SANITARY SEWER

EXPLORATION PLACE ADDITION

2024-021284PPS (53030982)

SANITARY SEWER IMPROVEMENTS

SANITARY SEWER LINE 1
PLAN AND PROFILE

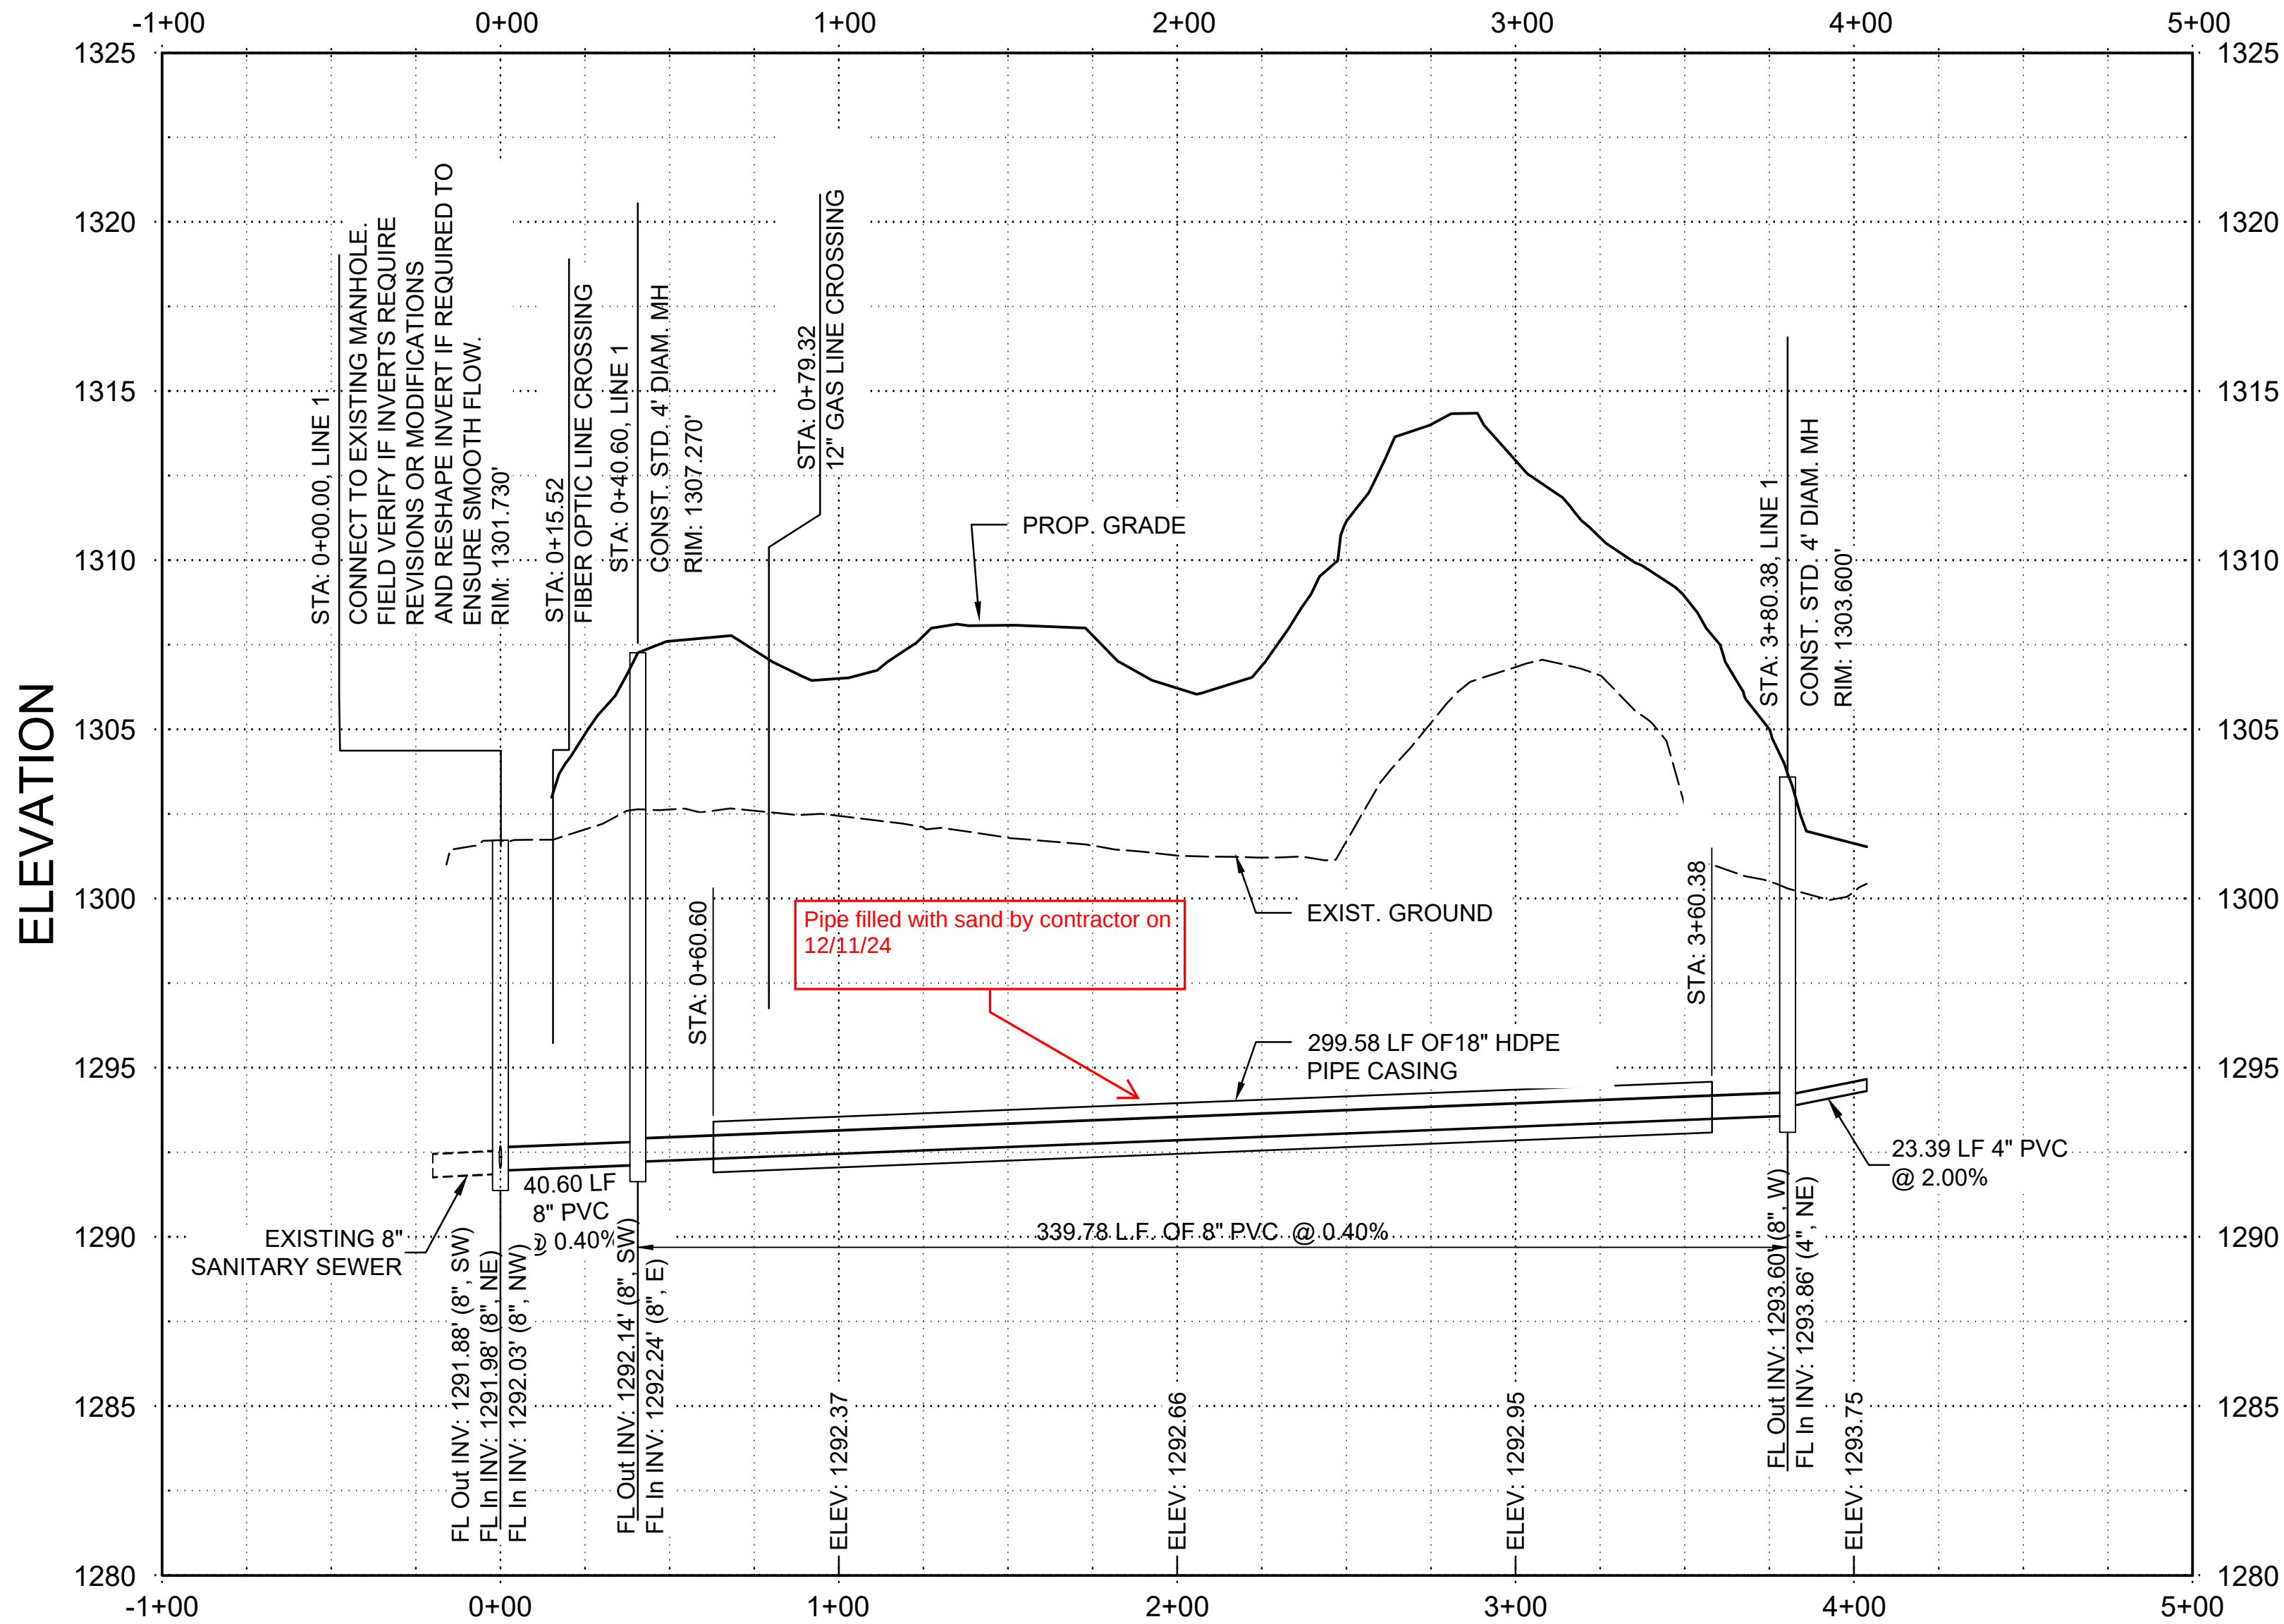
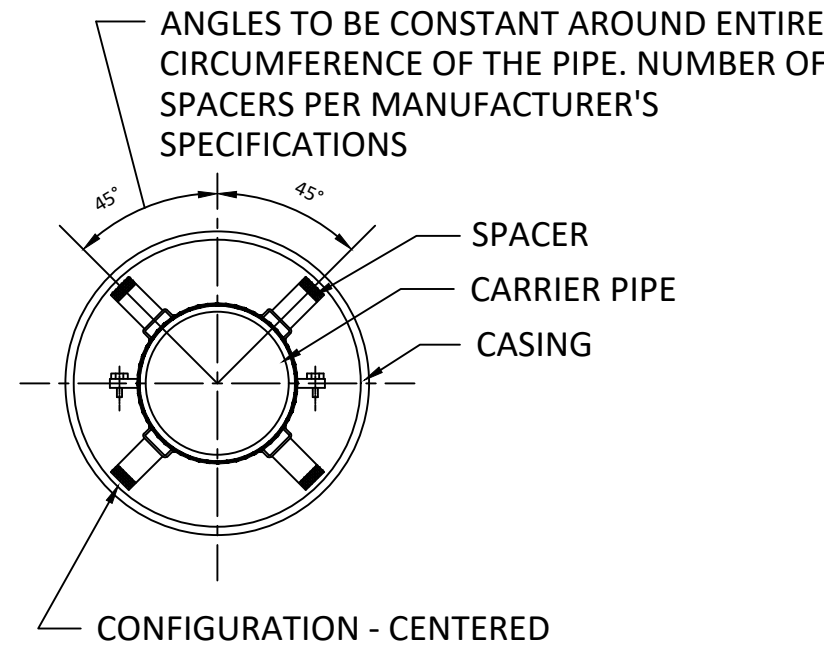
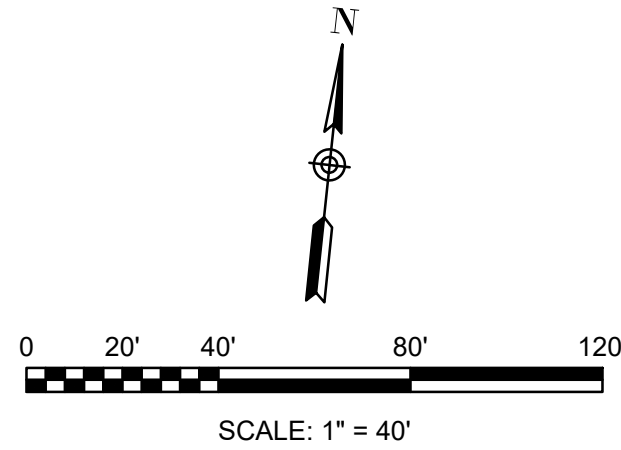
Not Built As Per Plans; MH 1-1 Placed 2' North of planned location, due to upstream lateral line proximity to adjacent gas line to the South. Approved by Scott Servis, PE via Email on 11-6-24
